KAHN BANI SA'AD
CORRECTIONAL FACILITY
KAHN BANI SA'AD, IRAQ

SIGIR PA-08-138
JULY 25, 2008

SUBJECT: Report on Construction of the Kahn Bani Sa'ad Correctional Facility, Kahn Bani Sa'ad, Iraq (Report Number SIGIR PA-08-138)

Figure 2. Locations of low concrete strength

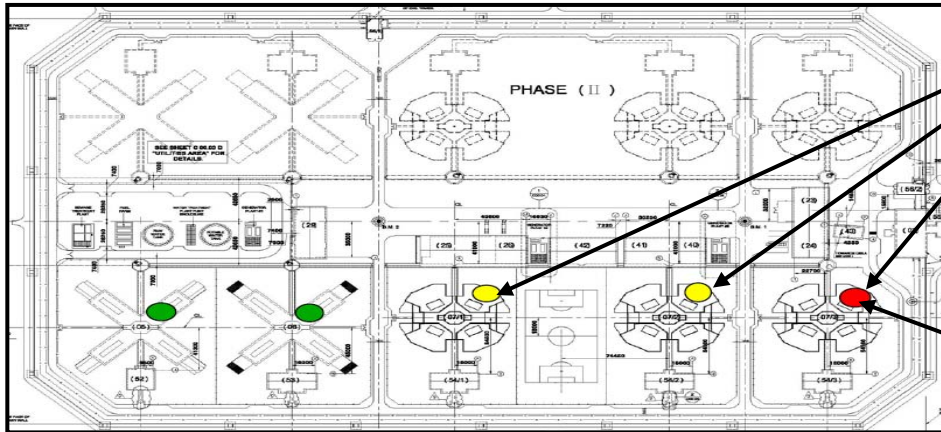
SIGIR used the structural assessment report to identify the areas where structural issues were present. Specifically, the locations where the thickness of the concrete floor slabs

was significantly less than required by the contract designs (Figure 2 and Site Photos 7 and 8).

Site Photo 12. Exterior view of the maximum security building – no corrective action had been taken by the GoI

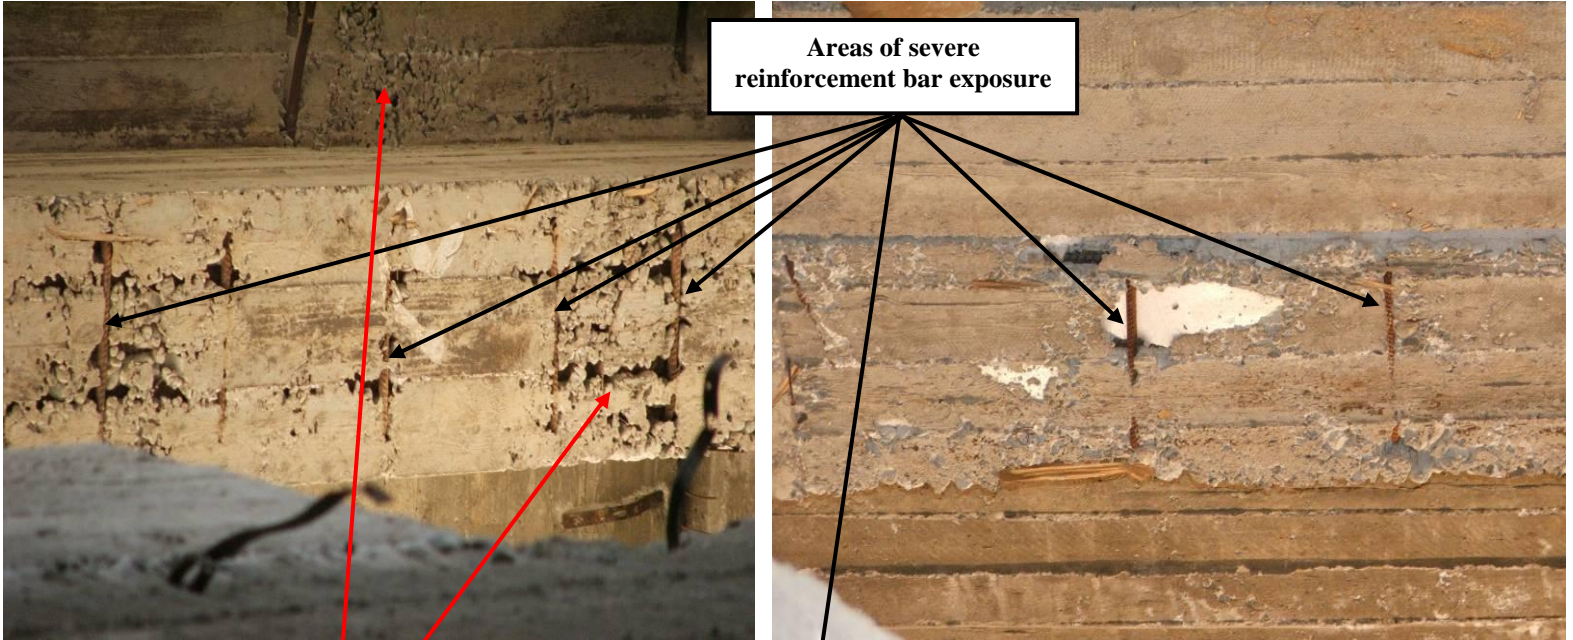
Due to time constraints, SIGIR could not inspect all buildings diagnosed with a lack of reinforcement bar, low strength of concrete blocks, and poor quality construction. SIGIR toured the maximum security building (Site Photo 12) and observed that the assessment's recommendation to demolish all un-reinforced walls and reconstruct with appropriate reinforcement was not accomplished.

Site Photos 13 and 14. Severe reinforcement bar exposure on the surface of load-bearing reinforced concrete ceiling beams

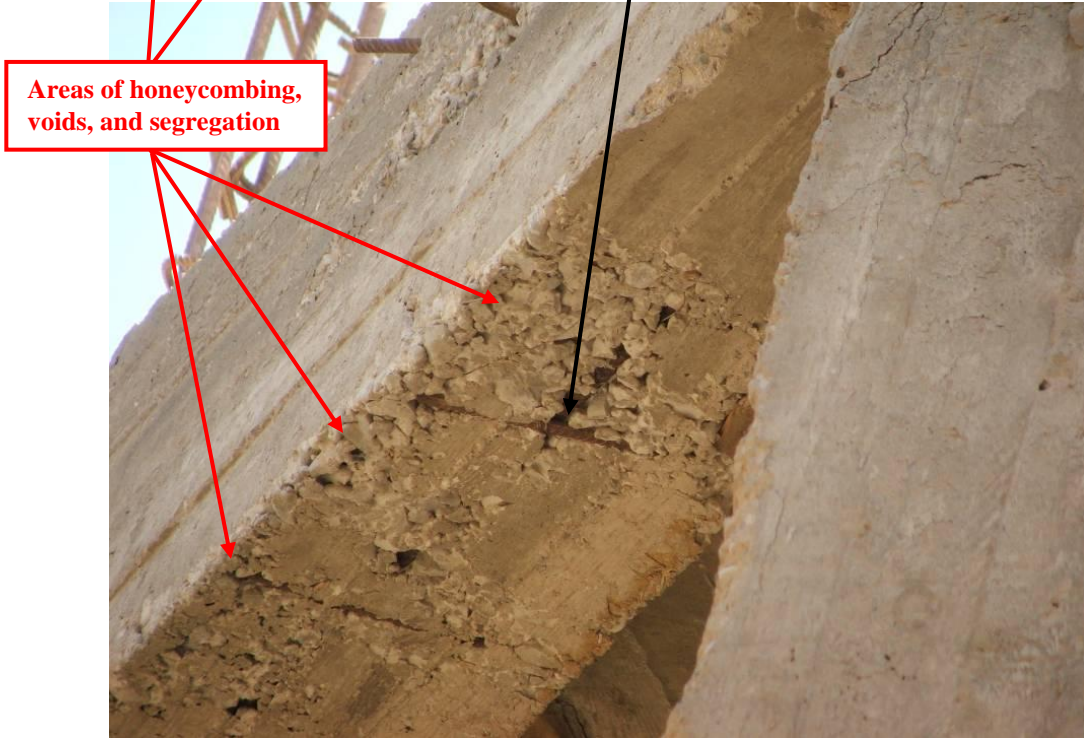
- areas of severe reinforcement bar exposure on the surface of the load-bearing reinforced concrete ceiling beams (Site Photos 13 and 14)
- areas of severe concrete segregation and honeycombing (Site Photo 15)
- potentially dangerous building columns (Site Photos 16-18)
- poor quality brick workmanship (Site Photo 19)

If the GoI plans to use this facility in the future, SIGIR concludes these deficiencies (along with the others previously noted) require attention.
